TERRA MONT SUBDIVISION (P.U.D.)
SAN ANTONIO, TEXAS
PLANNED UNIT DEVELOPMENT
MASTER PLAN

A memo from the
CITY of SAN ANTONIO
Development Services
Master Development

SUBJECT: # 07-004

Name: Terra Mont Sub. PUD

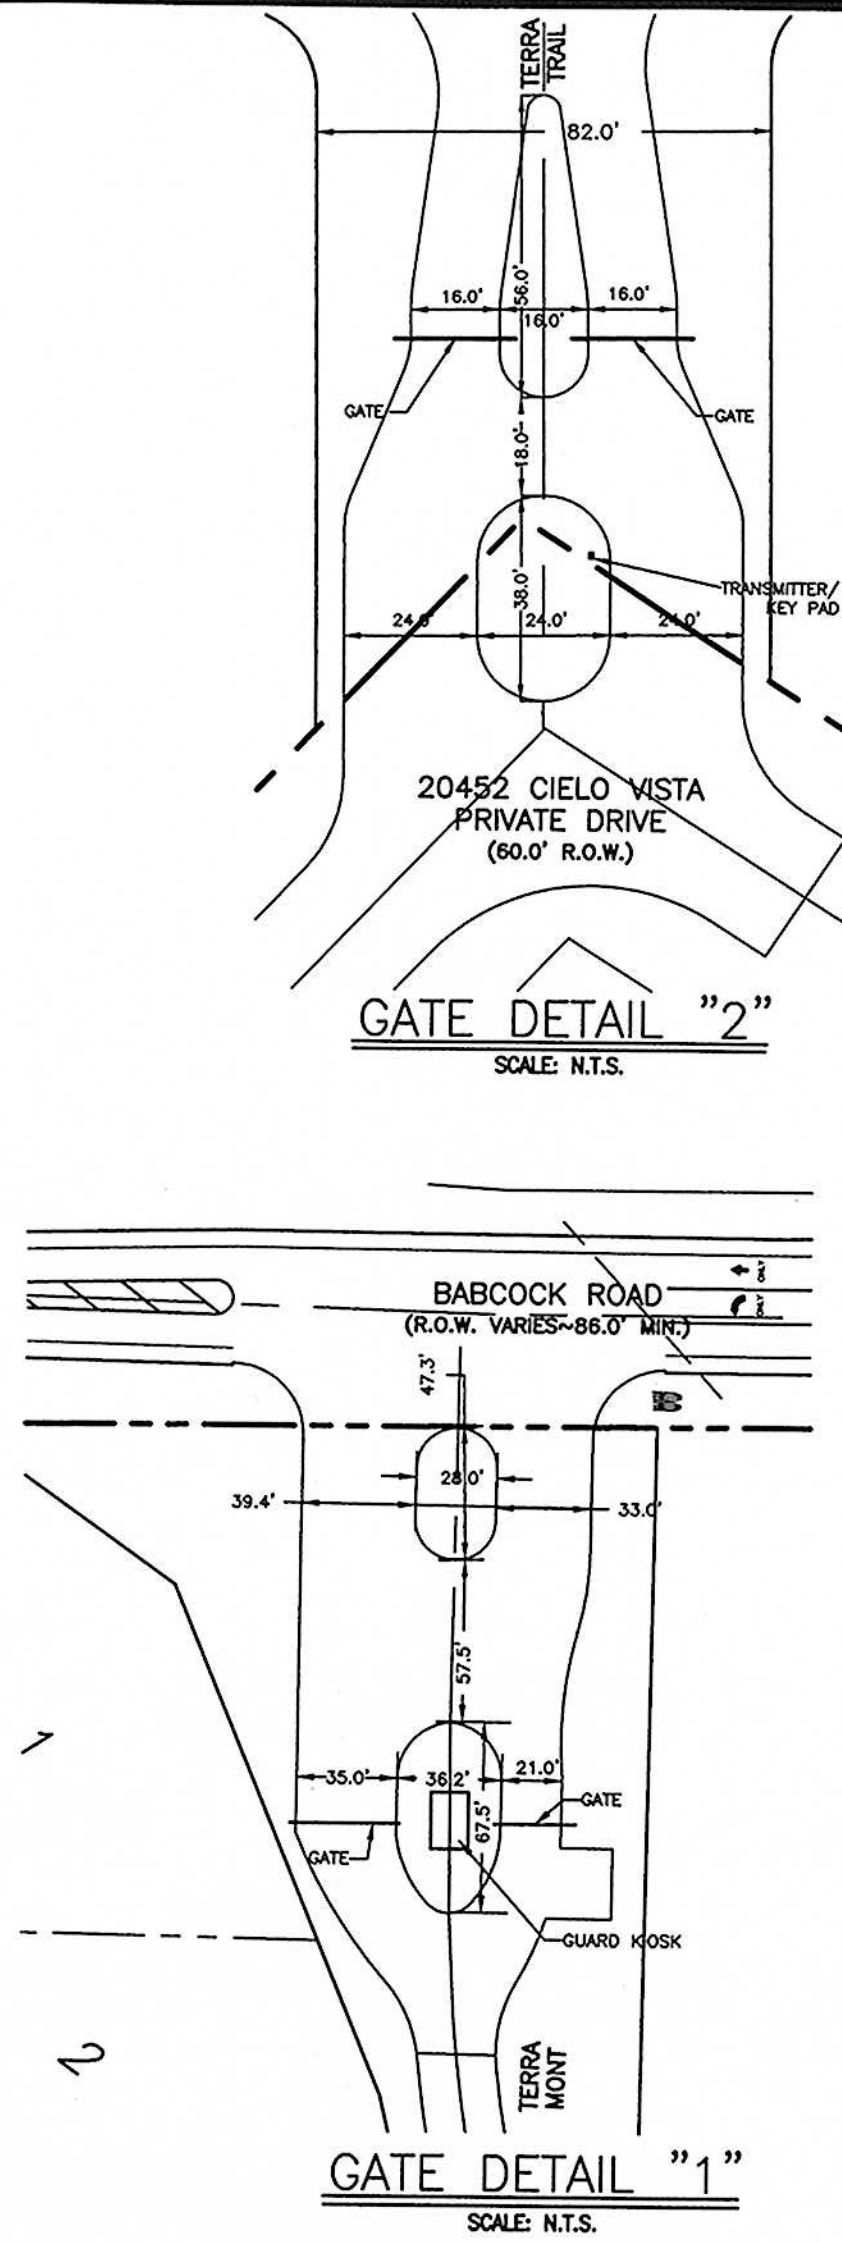
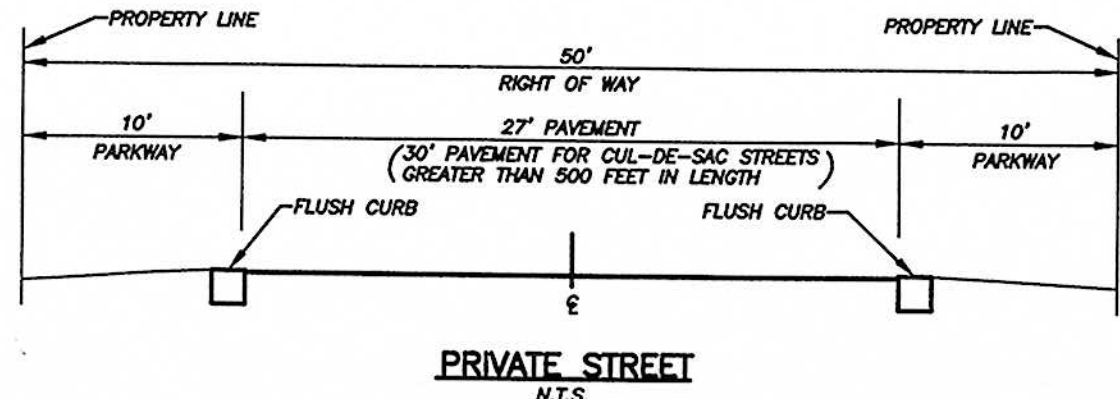
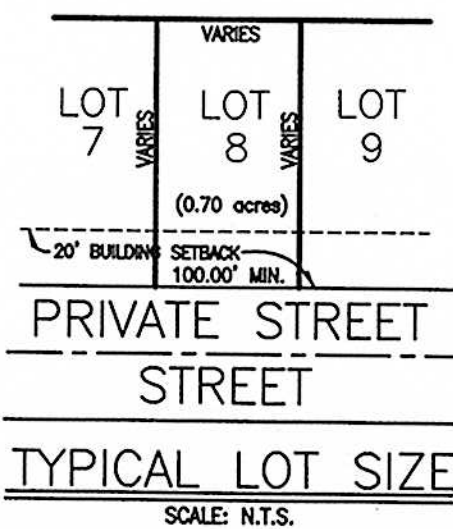
Historic Preservation states the following: The Texas Sites Atlas indicates that archaeological sites have been previously identified within or nearby the above referenced

property. Also, the property may contain historical architectural sites, some of which may be significant. Thus, before any work that might affect any sites is begun, we recommend that qualified professionals conduct an archaeological and historical structures investigation of the property. The investigations should be performed according to Archeological Survey Standards for Texas, and previously identified sites should be reexamined and reevaluated, if any. The Council of Texas Archeologists provides a list of qualified consultants that can be accessed on-line at www.c-tx-arch.org. The consultant will probably need to obtain an antiquities permit from the SHPO prior to starting the investigation. A report of findings should be prepared according to the Council of Texas Archeologists [CTA] Guidelines for Cultural Resource Management Reports and submitted to the HPO and SHPO for review. Copies of the survey standards, the CTA guidelines, and a list of qualified consultants may be obtained by calling the SHPO at 512-463-6096 or writing to P.O. Box 12276, Austin, Texas 78711-2276. Any part of the property investigated since June 1, 2006 may be omitted and the report for the previous study may be submitted for that area. Law allows both the HPO and SHPO 30 days from receipt for reviews.

- 100 year Flood Plain Shown and Buffering (If applicable)
- Significant Recharge Features and Buffering (If applicable)
- Category Letter for All Site Specific Plats (If Category 2 or 3, an Aquifer Protection Plan is required (If applicable)
- Additionally, a Water Pollution Abatement Plan or Contributing Zone Plan must be submitted to and approved by the Texas Commission on Environmental Quality (TCEQ) prior to construction.

Additional Comments: According to the Aquifer Protection Ordinance# 81491, section 34-914, buffering may be required. Any existing wells found on the site shall be plugged by the property owner in accordance SAWS regulations.

- All access driveways shall comply with UDC 35-506(r)
- All Roadways shall conform to Table 506-2 Functional Classification System Description for Traditional Design Classification.
- The developer shall be responsible for providing left-turn lane, with storage lengths and bay taper as it relates to the submitted TIA traffic count, Unified Development Code (UDC)-35-502 (a) (7), subsection D.

- All access roadways shall provide clear sight distance on all existing and proposed roadways in order to provide adequate obstruction free viewing distances for approaching traffic. All signage, landscaping, and improvements shall be selected and located so as to not block these clear sight distances areas.

- The parkland provided shall be shown as "Park" or "Open Space" on a plat; UDC section 35-503(e) *Designation of Parkland*.
- The parkland provided is dedicated to the Home Owners Association.
- The instruments creating the Home Owners Association are provided by the second application for plat approval; UDC section 35-503(e) *Designation of Parkland*.
- Parkland dedication must be platted by the second phase of residential development; UDC section 35-503(f) *Development Phasing*.
- All amenities provided shall comply with standards and specifications found in UDC Section 35-503 (h) *Credit for Park Facilities* and Table 503-4 if any credit is to be awarded.
